**Rezoning from “Residential (Group C) 2” and “Open Space” zones to  
“Residential (Group C) 4” zone for a Proposed Residential Development  
at Lot Nos. 519 RP (part) and 520 RP in D.D. 110 and adjoining Government land,  
Shek Kong, Yuen Long, N.T.**

**(S12A Amendment of Plan Application No. Y/YL-KTN/6)**

**- Further Information No. 1 -**

**Comments Forwarded from Fanling, Sheung Shui and Yuen Long East District Planning Office**

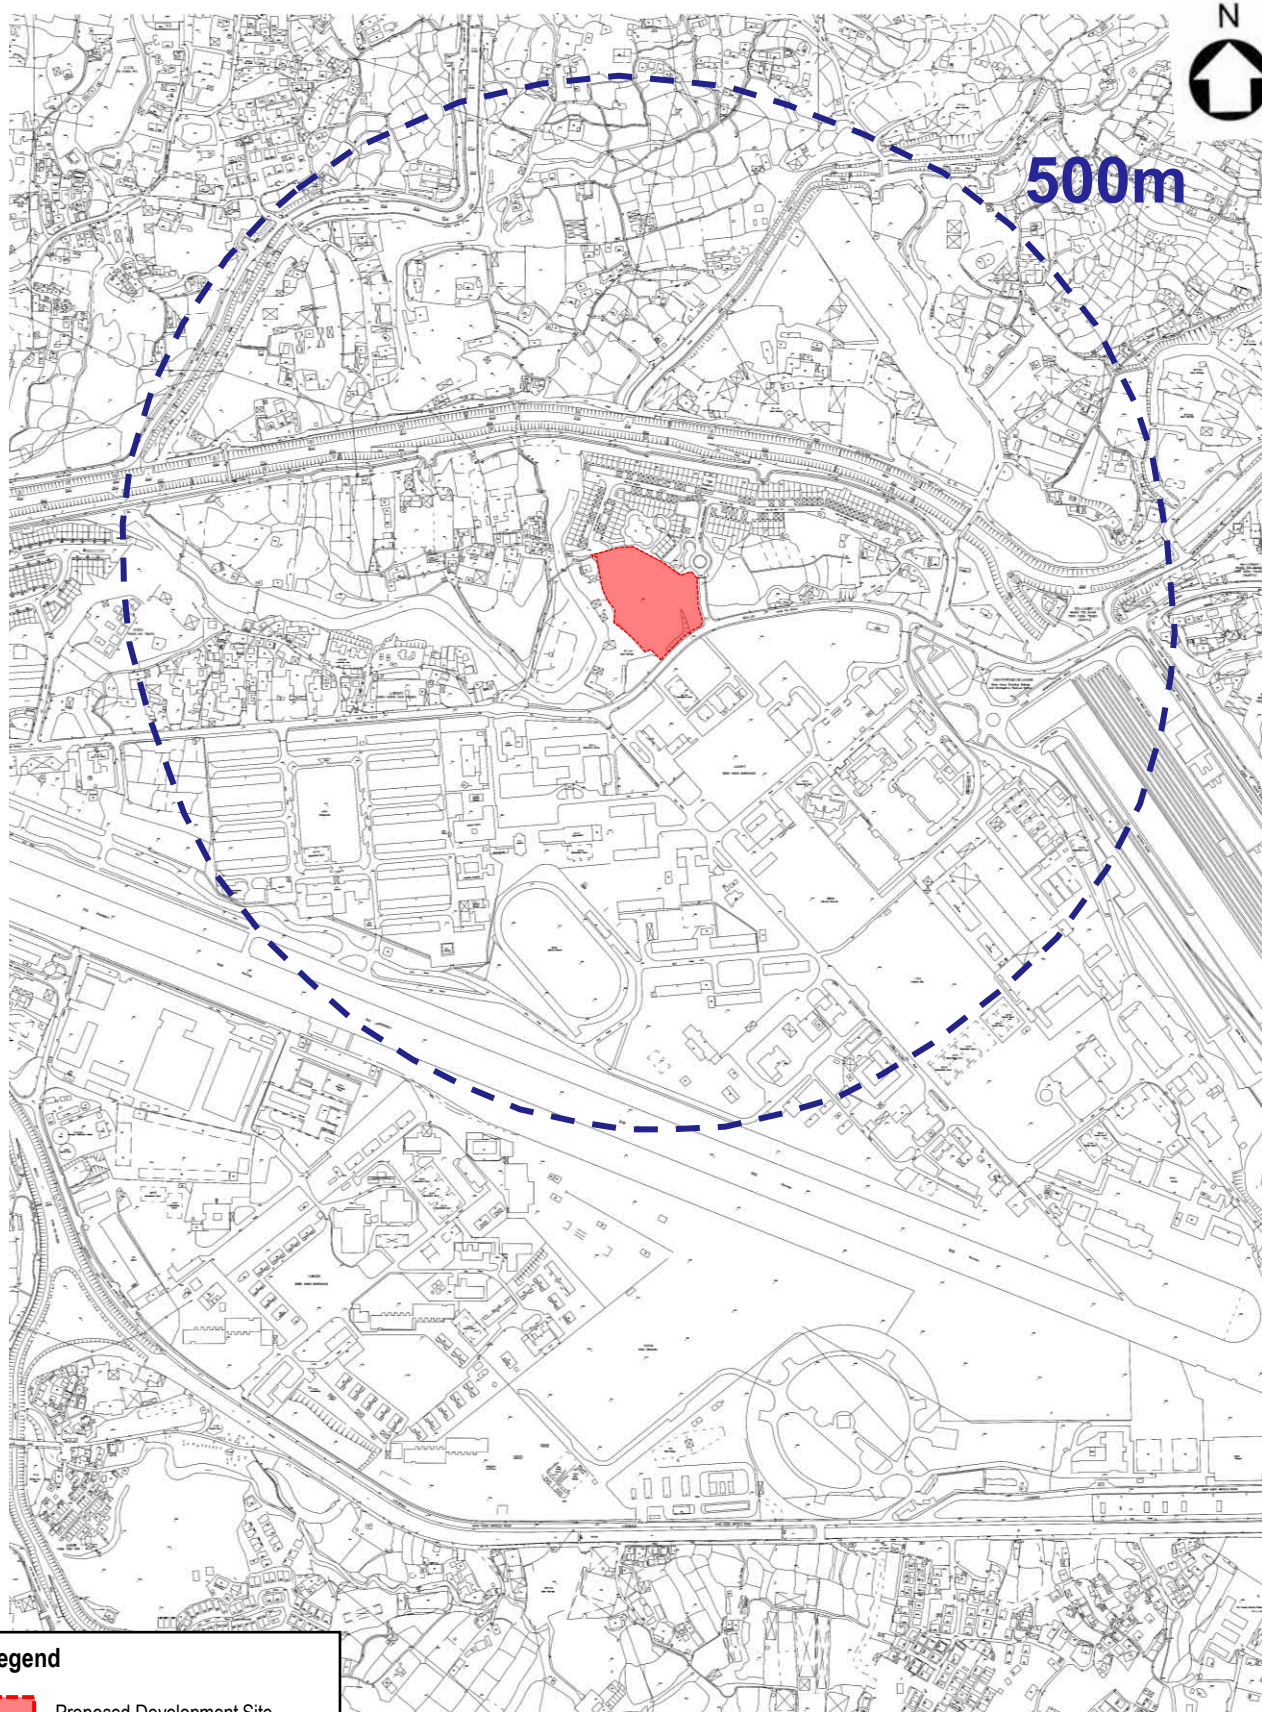
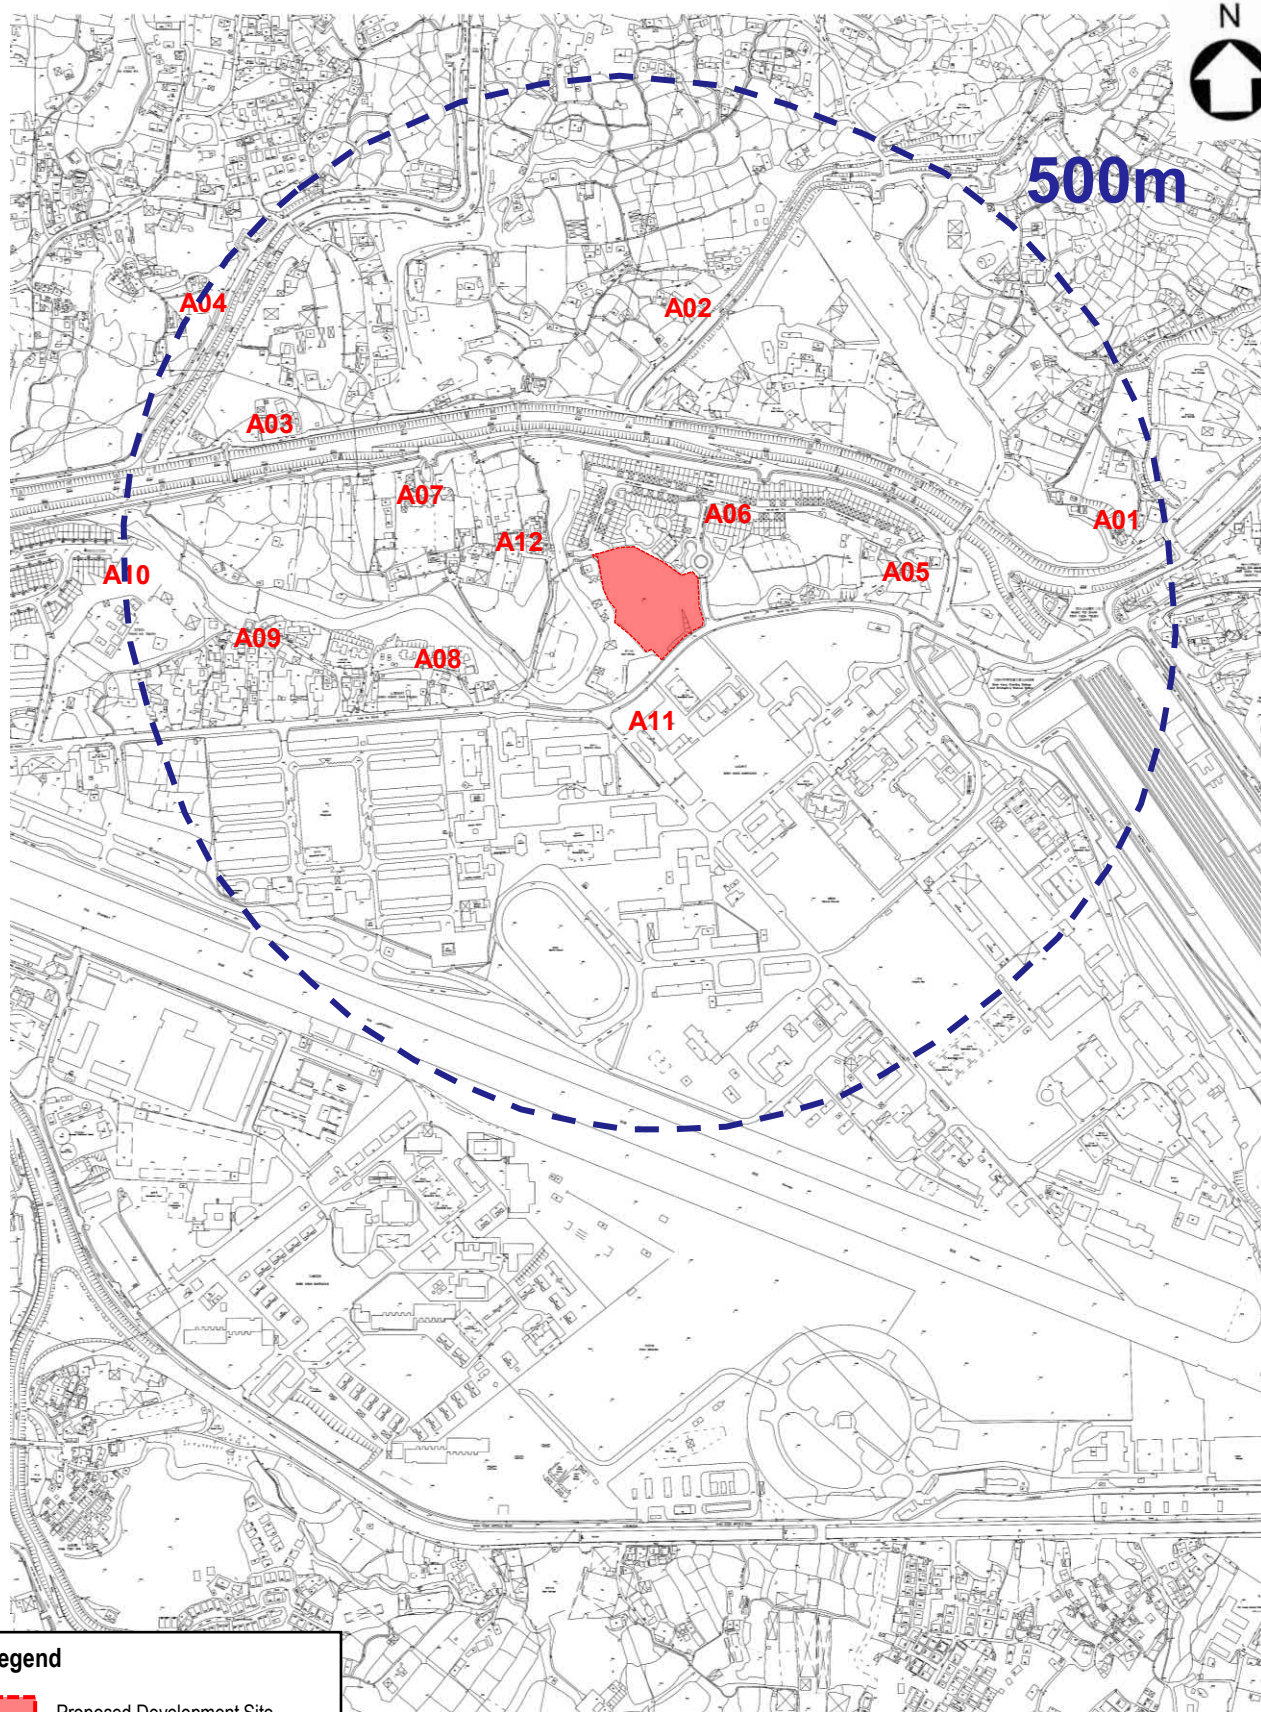
| Comments                                                                                                                                                                                                                                                                                                                                                                                                                                                                                                                                                                                                                                                                                                                                                                                                                                                                                                                                                                                                                                                                                                                                       | Responses                                                                                                                                      |
|------------------------------------------------------------------------------------------------------------------------------------------------------------------------------------------------------------------------------------------------------------------------------------------------------------------------------------------------------------------------------------------------------------------------------------------------------------------------------------------------------------------------------------------------------------------------------------------------------------------------------------------------------------------------------------------------------------------------------------------------------------------------------------------------------------------------------------------------------------------------------------------------------------------------------------------------------------------------------------------------------------------------------------------------------------------------------------------------------------------------------------------------|------------------------------------------------------------------------------------------------------------------------------------------------|
| 10. Figures 1, 2 and 5a - The assessment area should be 500m measured from the boundary of the project site, thus it should not be a circle. Please revise.                                                                                                                                                                                                                                                                                                                                                                                                                                                                                                                                                                                                                                                                                                                                                                                                                                                                                                                                                                                    | Figures 1, 2 and 5a are revised. The assessment area is now drawn according to the 500m area generated by the SAMP v2.1.                       |
